Access Compliance Report

Development Application

Development Address: 185 Fifth Avenue, Austral

Client: GM Architects

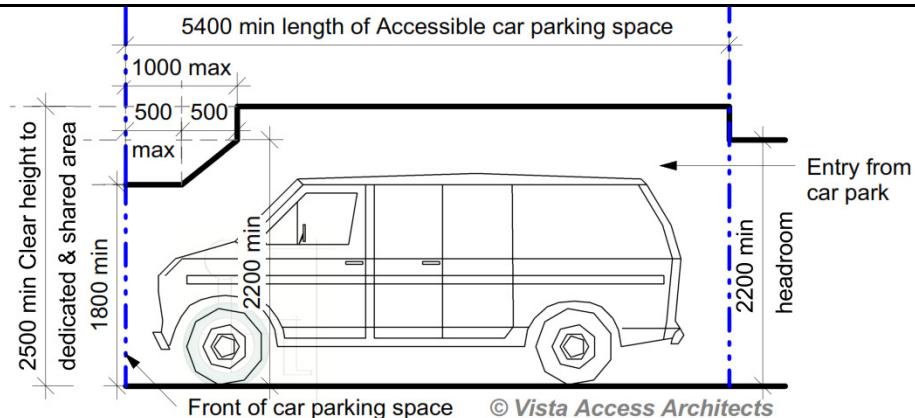
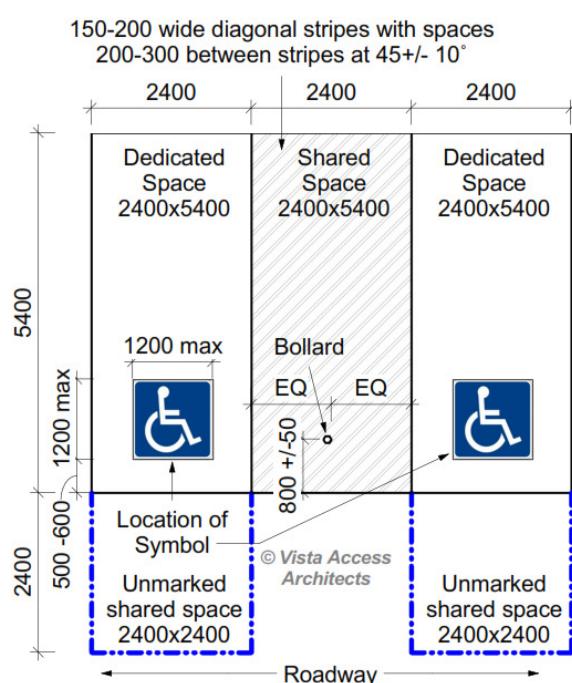
Head heights for both dedicated accessible parking space and the shared zone to be as shown above. No beams, pipes, sprinklers or any other encroachments are permissible for the entire 5.4M width of the dedicated and shared zone as per Section shown above.

The Accessible parking, shared zones, linemarking and symbols to be as shown above.

Type 2
Pre Adaptable

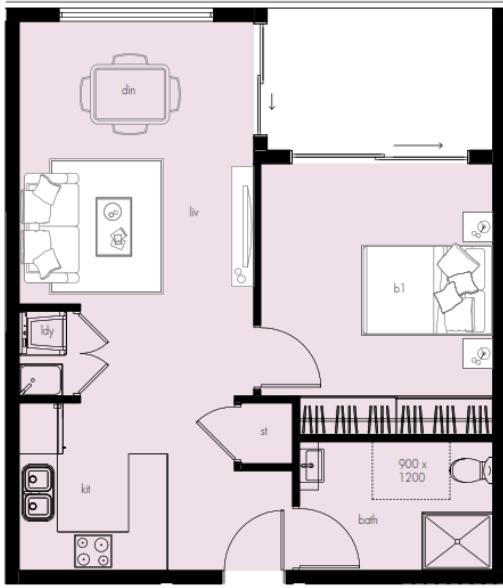
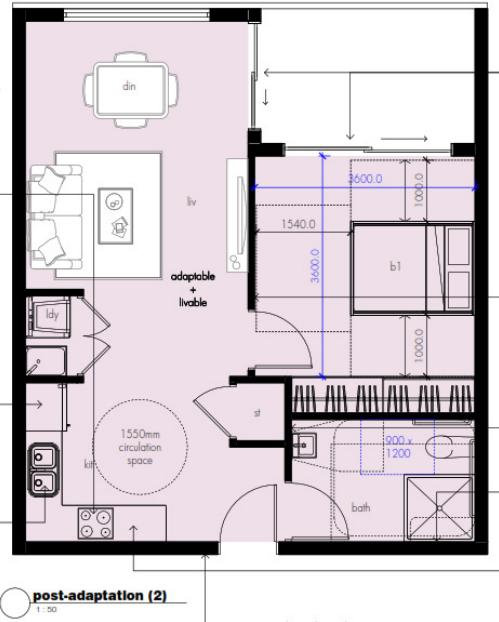
cooktop to include front or side controls with raised crossbars and isolation switch.

fridge GPO locates on wall in easily reachable position while in operation.

tap set within 300mm of sink

Post Adaptation bathroom layout shown

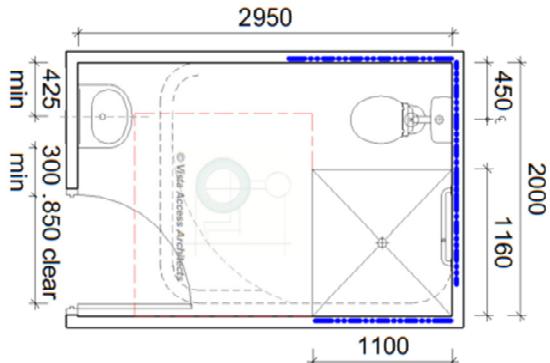
Noted dimensions in these diagrams are approximate and depend on selected features such as size of the basin. These dimensions include allowances for reinforcements and construction tolerances. Thick blue line indicates the location of wall reinforcements. Red dotted line indicates the shower circulation space. Black dotted line indicates the WC pan circulation space.

<ul style="list-style-type: none"> Provision for bathroom area with Circulation spaces of Shower and WC (including fixtures) to comply with AS1428.1. Note that wall reinforcements and waterproofing details to comply with AS4299 	<input checked="" type="checkbox"/>	<input checked="" type="checkbox"/>	<p>Complies</p> <p>A bathroom with minimum space of 2Mx 2.95M or 2.3Mx2.7M or 2.4Mx2.45M is achievable. Wall reinforcements to be verified at the CC stage.</p>
---	-------------------------------------	-------------------------------------	---

Wall reinforcement requirements

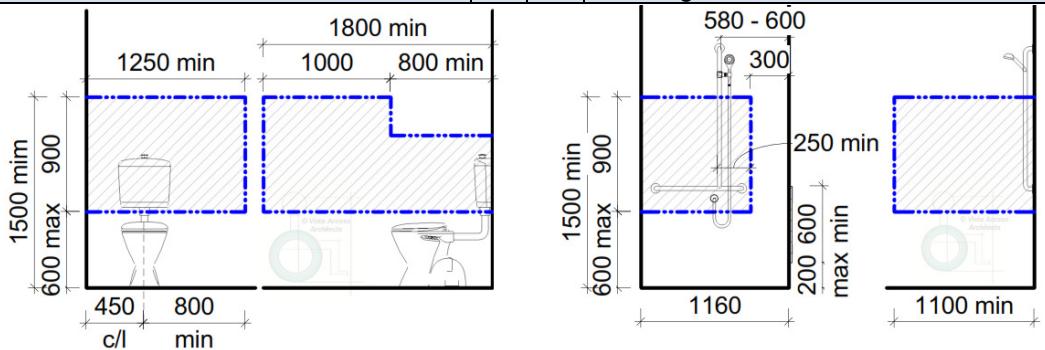
Reinforcement requirements for the Adaptable unit for WC and shower (in post-adaptive position) showed hatched. Refer to AS4299 for further details.
